MKL S1 4/1/15
REDLINE 15-0062

A1-1
FIRST FLOOR PLAN

GRIME STUDIOS
PORTLAND, MAINE

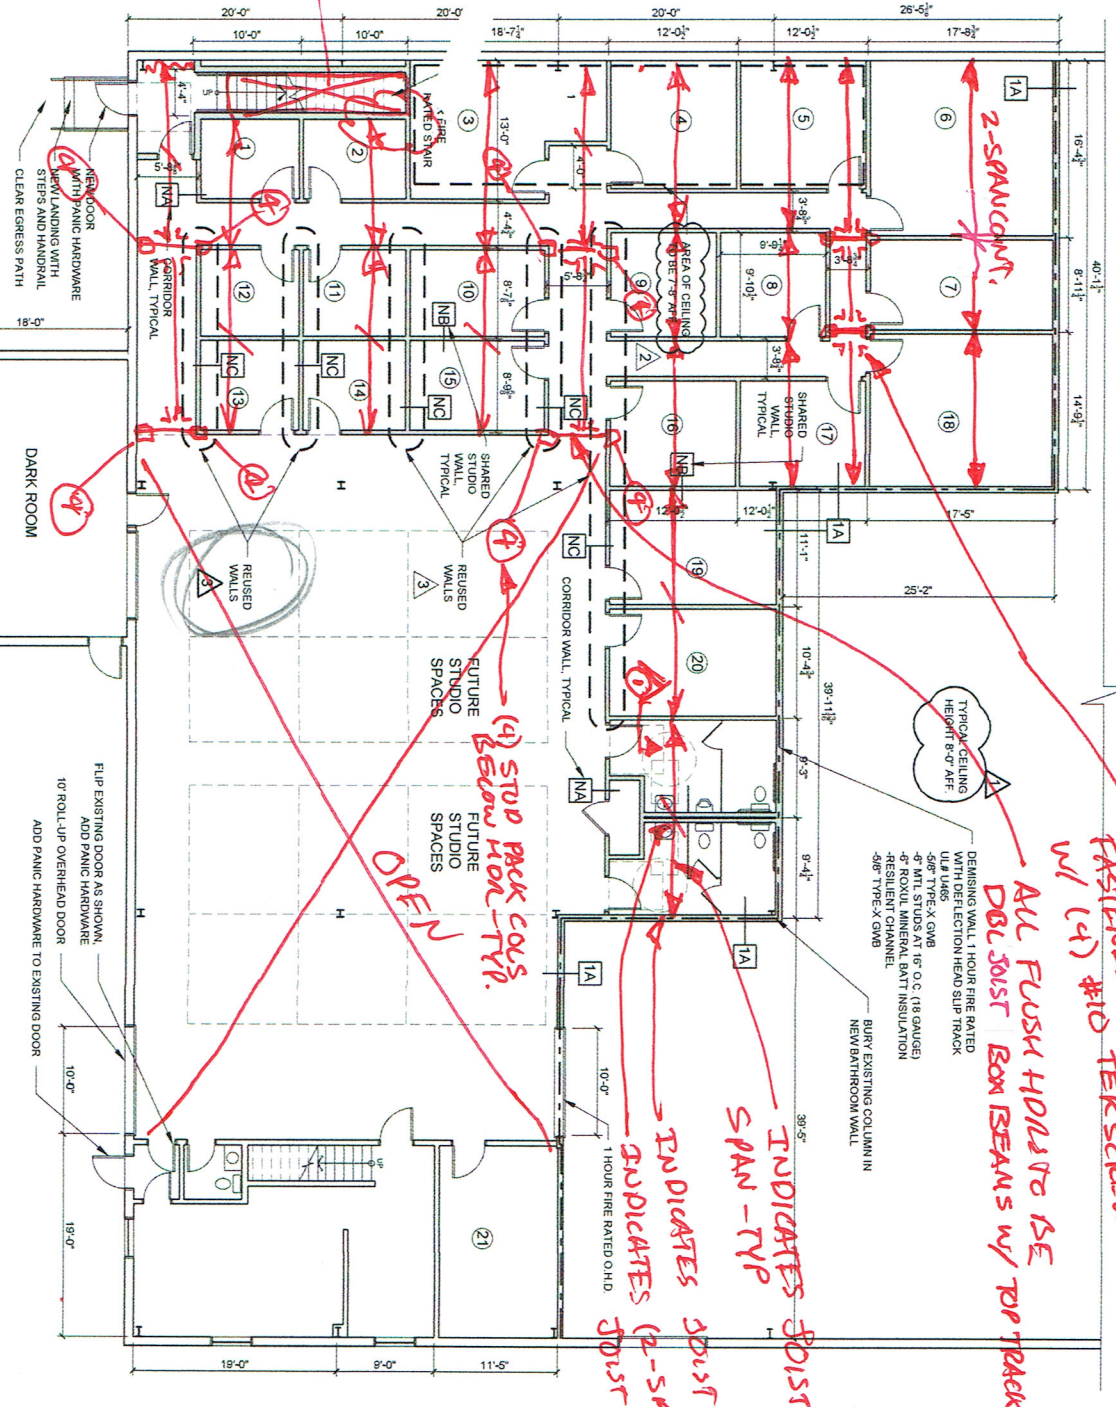
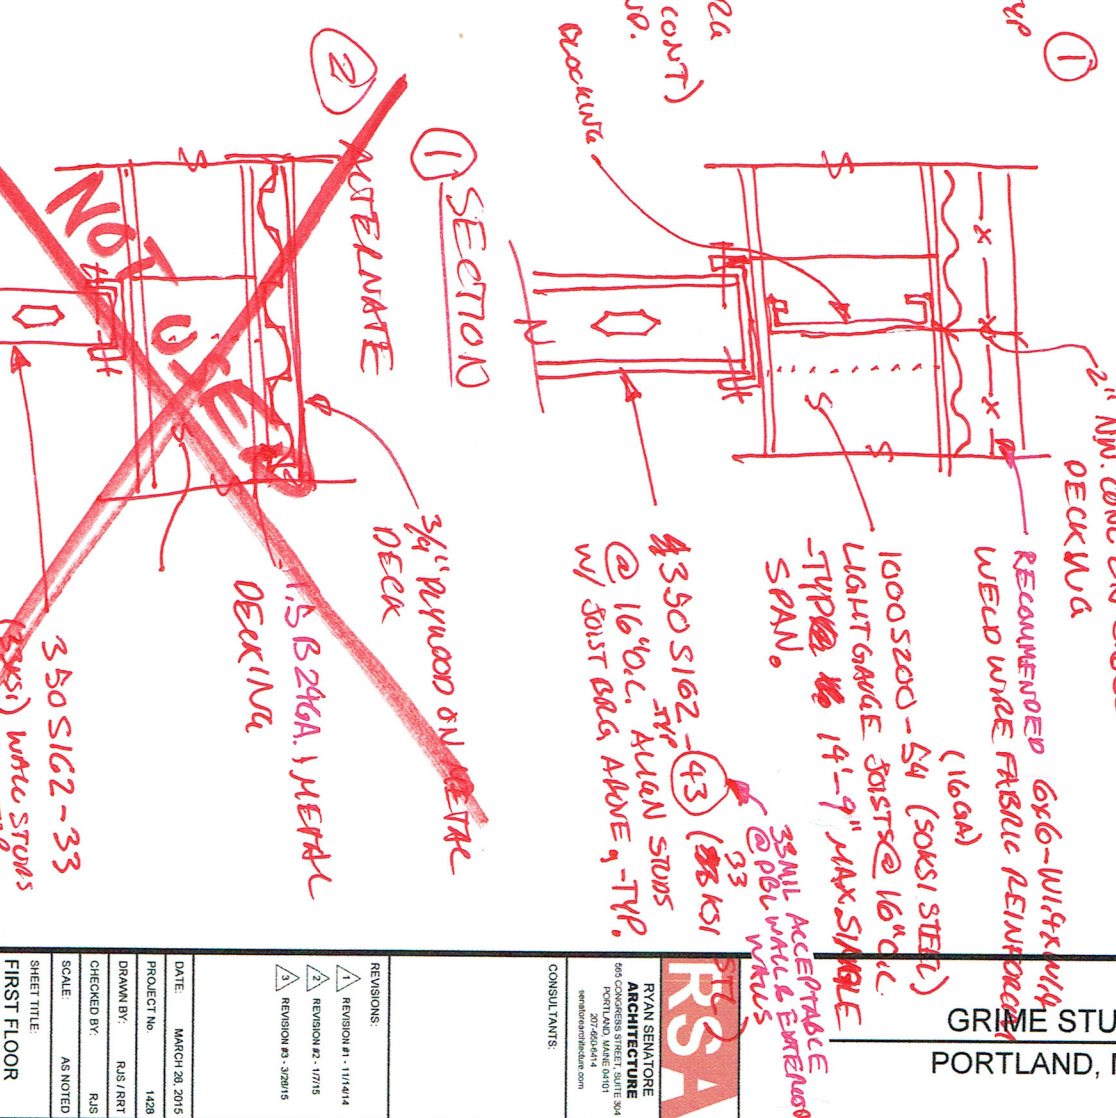
DO NOT BEAR ON THIS WALL - ALL COLUMNS USE ALL PLATE CANT FROM PLATE. PROVIDE DBL FULL HEIGHTS FOR RAY SENIGORE @ (E) PANEL ENDS
